ATTACHMENT 1

Proposed Amendment 153a

This proposed amendment (PA) modifies the following Kewaunee Nuclear Power Plant (KNPP) TS:

PROPOSED TS AMENDMENT NO. 153a

FIGURE TS 3.1-3

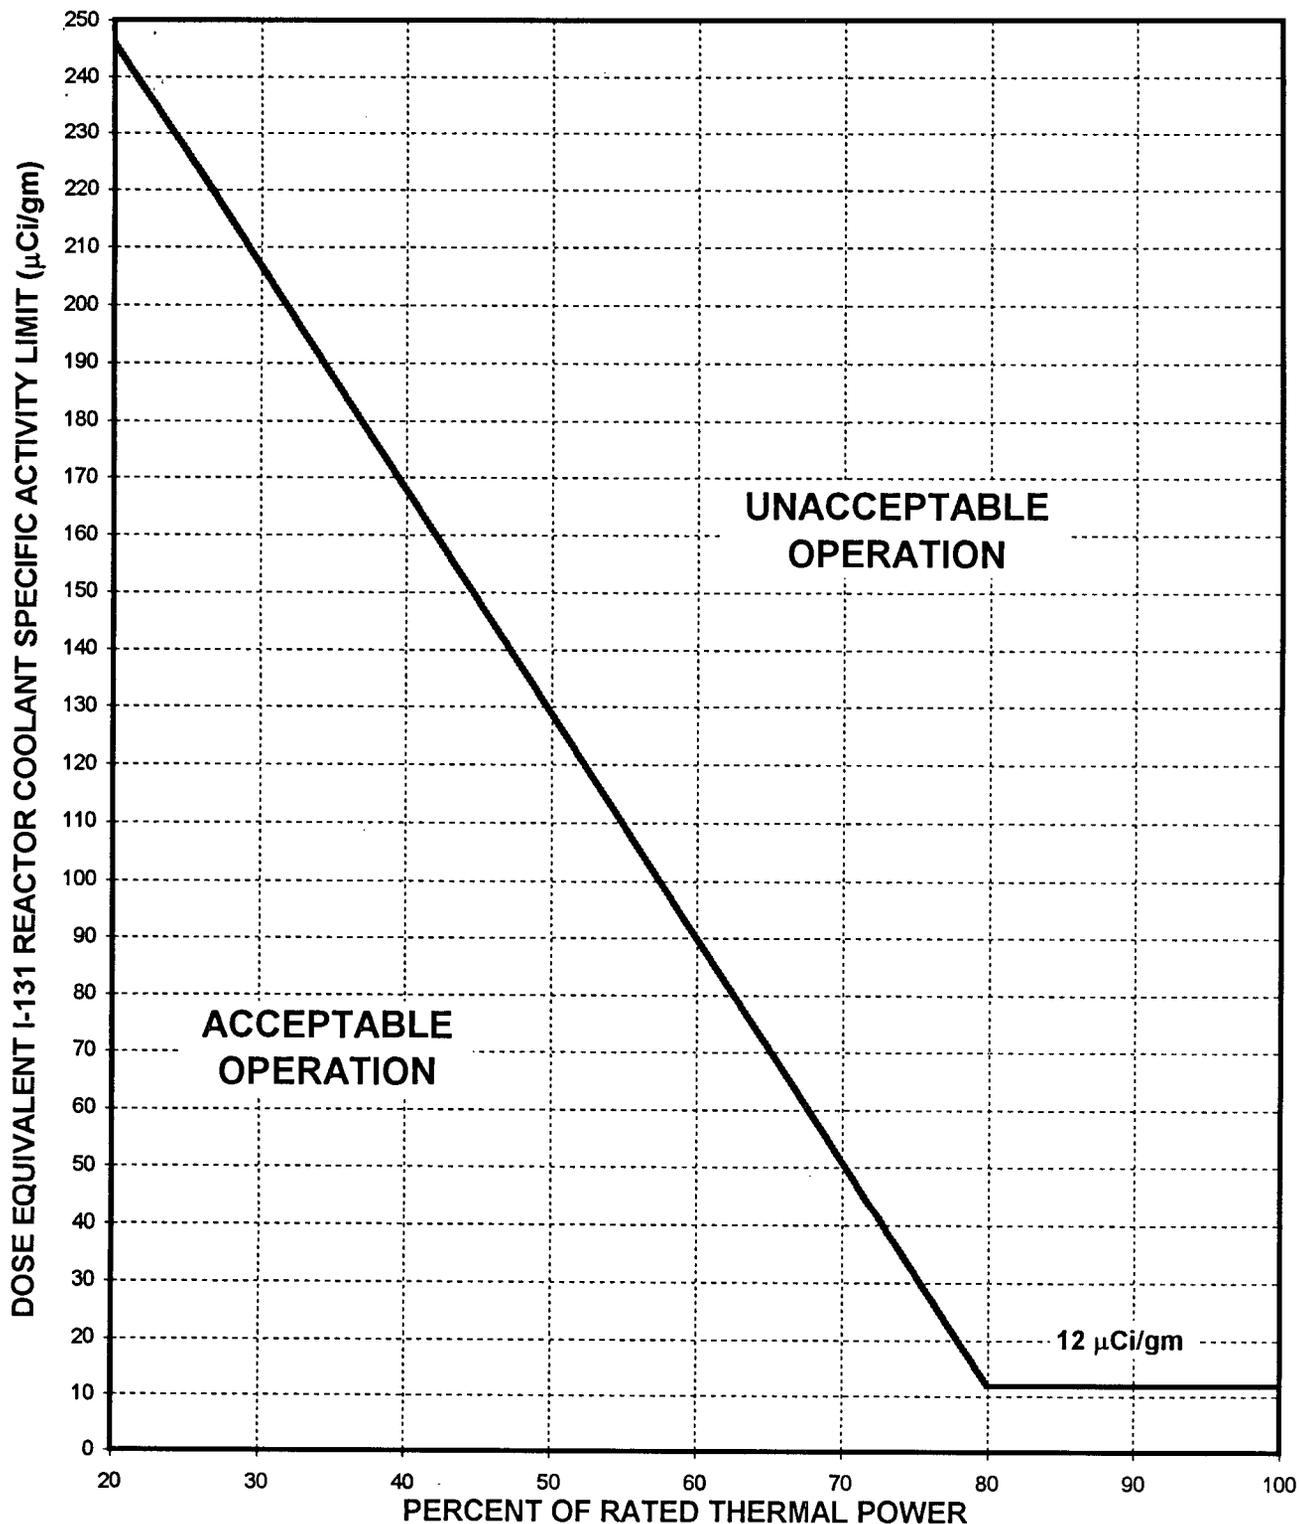
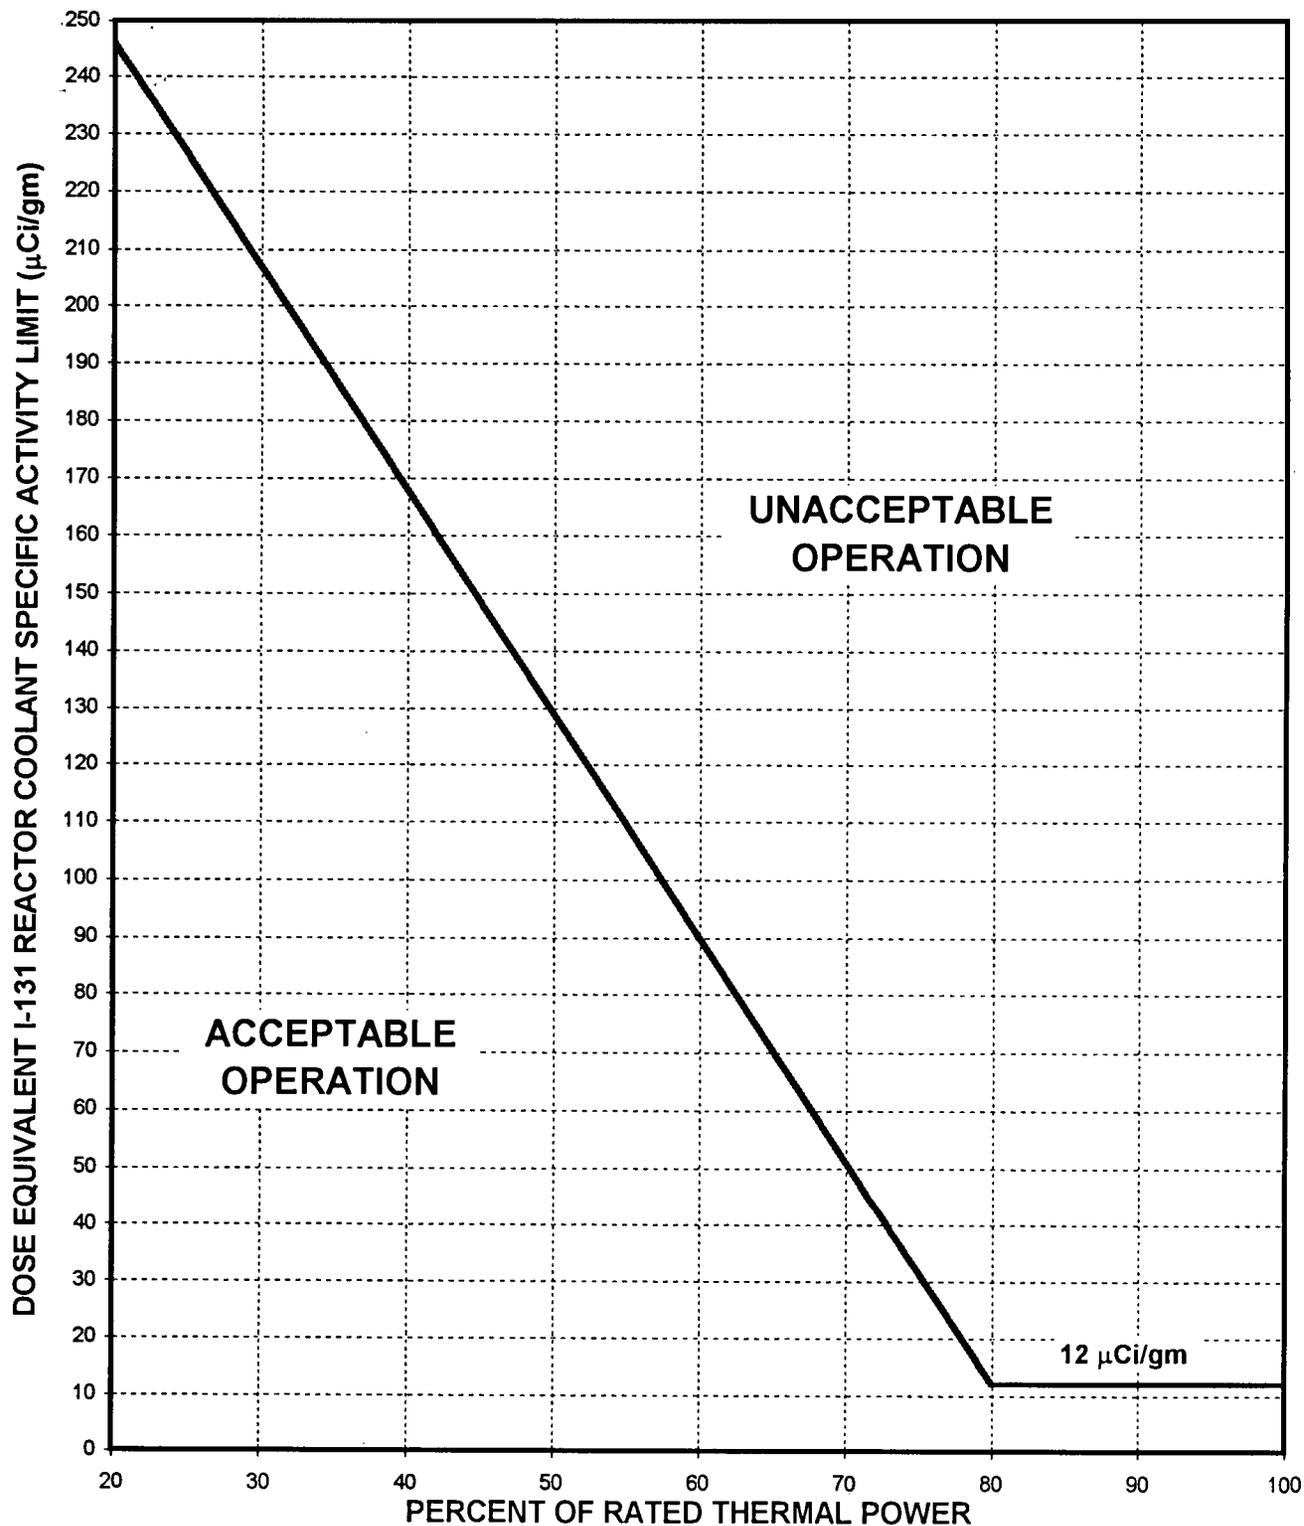
2. Figure TS 3.1-3 is being revised to reflect the new reduced limit on reactor coolant specific activity. The curve on the graph is being lowered by a factor of 0.80 as applied to specific activity limits of Westinghouse standard technical specifications (STS). This change results in a full power specific activity limit of 12  $\mu\text{Ci}/\text{gram}$  dose equivalent I-131 as compared with the STS limit of 60  $\mu\text{Ci}/\text{gram}$  dose equivalent I-131. The new curve parallels the STS curve. The change is in accordance with the GL 95-05 guidance and is supported by the calculation.
